Re: FortisBC Energy Inc. (FEI)

Application for a Certificate of Public Convenience and Necessity (CPCN) for the Tilbury Liquefied Natural Gas (LNG) Storage expansion (TLSE) Project (Application)

Response to the British Columbia Utilities Commission (BCUC) Information Request (IR) No. 1

Cumulative 1-Day Demand

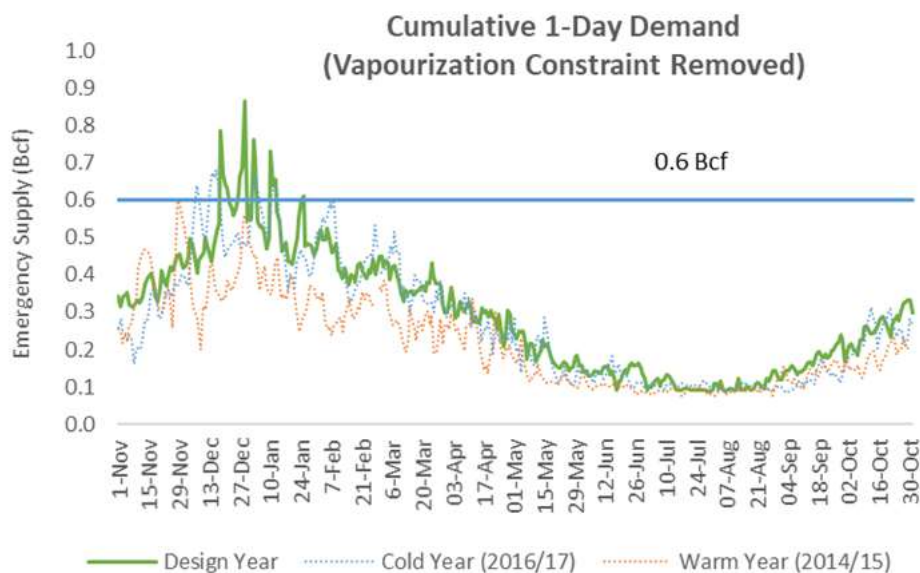
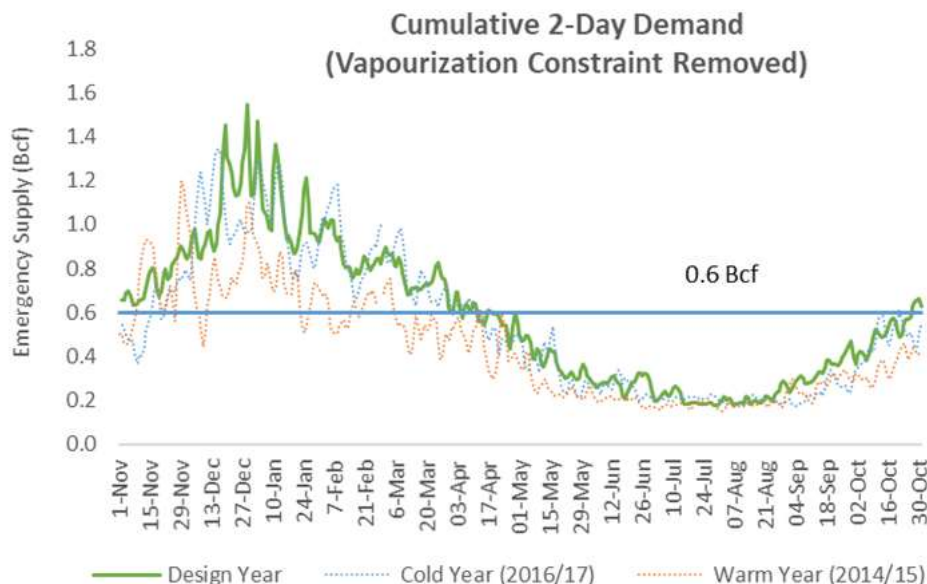
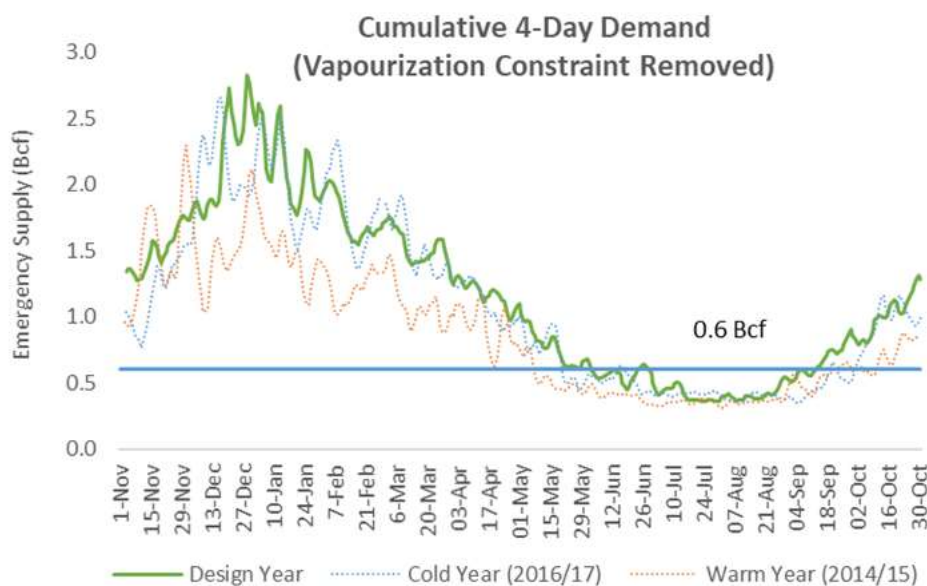
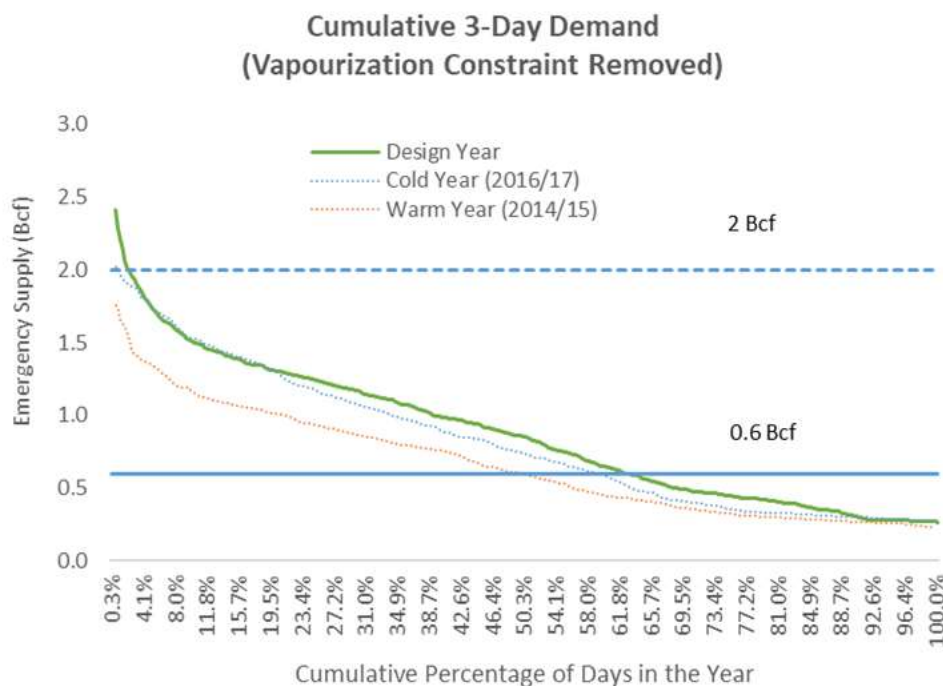
11.4 Please provide versions of the diagram on page 39 of Exhibit B-4 “Adequacy of Current Storage – Duration” showing the adequacy of current storage for:

11.4.1 Please also provide a version of the diagram on page 39 of Exhibit B-4 with the demand values on the load duration curve arranged from largest to smallest. Please include percentage intervals on the x axis to show the cumulative percentage of days in the year.

In the hypothetical case of the vapourization constraint being removed, the current Base Plant storage (0.6 Bcf) could provide adequate one-day demand in the summer as well as most days in the winter except the 15 coldest days in a design year:

- 1
- 2 **Cumulative 4-Day Demand**
- 3 Current storage can only provide adequate 4-day demand for some days in the summer but does
- 4 not meet the majority of the daily load requirements of the design year:

- 5
- 6 **Cumulative 3-Day demand arranged from largest to smallest**
- 7 In the hypothetical case of the vapourization constraint being removed, the following chart shows
- 8 the Lower Mainland load values sorted from largest to smallest. The cumulative percentage of
- 9 days in the year is displayed on the X axis.

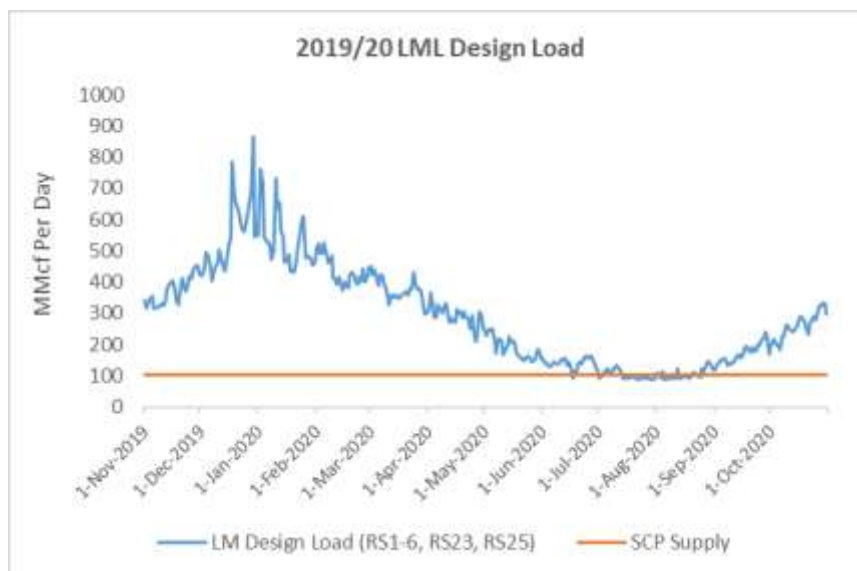
11.11 Please discuss whether 105 MMcf/day from Southern Crossing Pipeline (SCP) could serve LML demand in the event of a no-flow event on the T-South system occurring North of Kingsvale.

If a no-flow event on the T-South system occurs north of Kingsvale, the supply from SCP could serve some LML demand. This was shown during the T-South Incident, as Figure 3-7 illustrated in the Application. However, the portion of the 105 MMcf/day that could serve the LML would depend on the following factors:
